MEETING MINUTES - DAT #2

PROJECT BVSD Fairview High School MEETING DATE 2025.01.29

BY Chris Cole, MOA ARCHITECTURE LOCATION Fairview High School

Senior Lockers

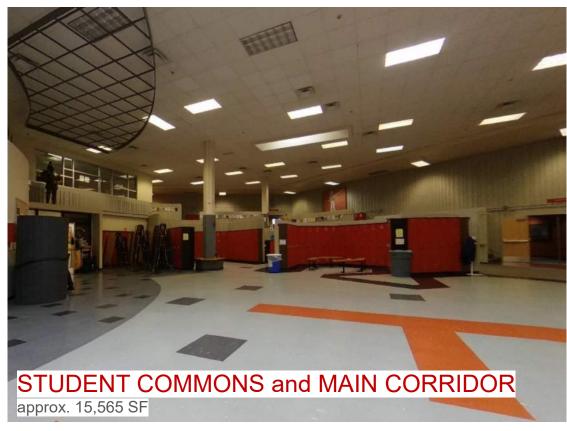
- Lockers identified as a mid-level priority due to the parts being discontinued and the damaged lockers. There did not appear to be a strong need to prioritize senior lockers.
- The preference is to have double lockers with sloped tops. Triple lockers could be considered if their count allowed for either less sharing of lockers or for the potential removal of some sections by the commons.

RM 408 CHEM LAB

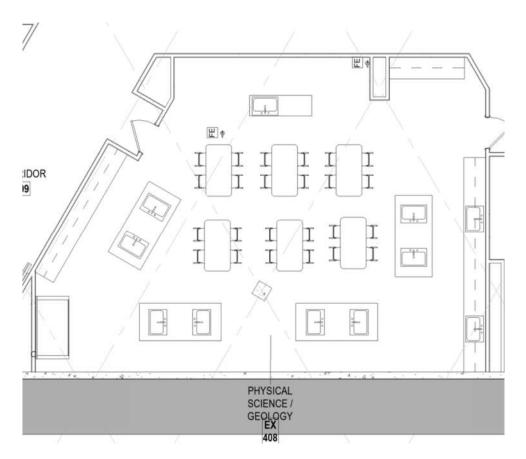
- Reviewed the science layout of classroom 408 to transition into a Chemistry room.
 - o Add fume hood consider venting requirements.
 - o Hot plates voltage requirements
 - o Gas at each station.
 - One sink per group at the perimeter of the room.

- Discussed bumping out the wall but that might be challenging if it is a bearing wall.
- o Prefers the flexibility of the furniture and lab stations.
- See additional notes from the site walk.

- i. Consider a new teaching wall in 408 since the column is in the way.
- ii. Fume hood match existing there is one fume hood that does not work. The existing fume hoods have a sink, gas and water (hot not confirmed). Venting of fume hood 408 may be challenging as there is a classroom above.

- iii. Will need peg boards at each station.
- iv. Prefers epoxy countertops with the lip edge to prevent liquids from coming down on the cabinets. Stainless steel sinks.

- v. Gas to be located on the back wall.
- vi. General exhaust will need to be added this will likely also be required in other rooms. The biology rooms may need it based on the use of the spaces.

- vii. Mechanical smoke dampers may be required if they are not already installed.
- viii. Acids used likely do not require additional neutralizers. It would be preferred if we added one in the room that can be used as a demo. This could be in the teacher's station or a convenient location.

- ix. Currently this room has overhead power which the science team likes but the outlets seem a little dangerous for students.
 - x. Design team to confirm if a full shower is required currently, they only have an eye wash station.

Classroom 225

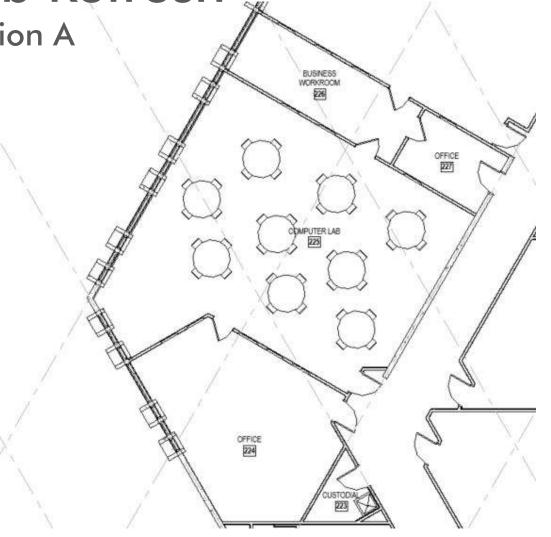
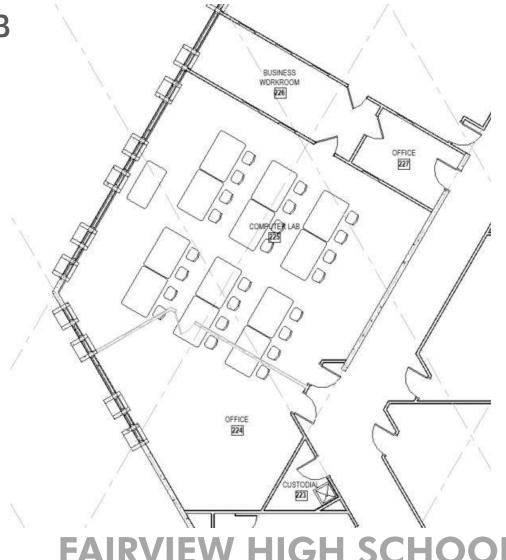
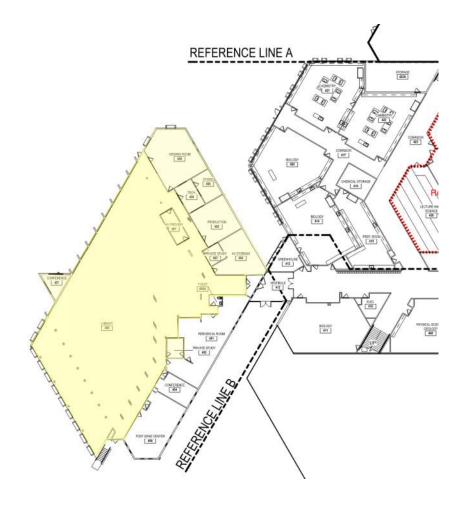
- Reviewed three layout options. Preferred option is to cut into business workroom 226 and office 227 but leave office 224 as existing.
 - o Room needs to fit 32-26 students.
 - o Needs space for laptops but also desktops with data.
 - Likes the idea of flexible areas but need to solve the issue of power and data. Power options are overhead, poles or chord rails that are low but not floor outlets. Design team will study options but the request is 12 outlets and 4 data connections.
 - Teaching station is required with desktop computer power and data.
- Add room 233 business class to the scope of Al.
- Add Culinary classroom to Al see notes from Culinary walk.

- a. 227 and 226 could be cut into to enlarge lab 225.
- b. Need to connect to the teacher station
- c. Look at floor poles (maybe mobile FF&E option?) for power
- d. Likes collaborative layout vs rows of desks
- e. Teacher wants to utilize plan southwest corner for an open workspace with power and some work tables
- f. Teacher doesn't have a strong preference for teaching wall location. The current classroom uses a large sort of sheet as a projector screen, but actual pull-down screen in the room is too small for teaching coding. The teacher requested that the teacher station be located next to the teaching wall.

- g. Business classroom to move to classroom above 225. Teacher requested removal of raised platform flooring and built-in counters along back wall. They would also like some way to get power to desk groups but has concerns about ceiling drops limiting the flexibility of layouts.
- h. A priority list was provided to MOA via email.
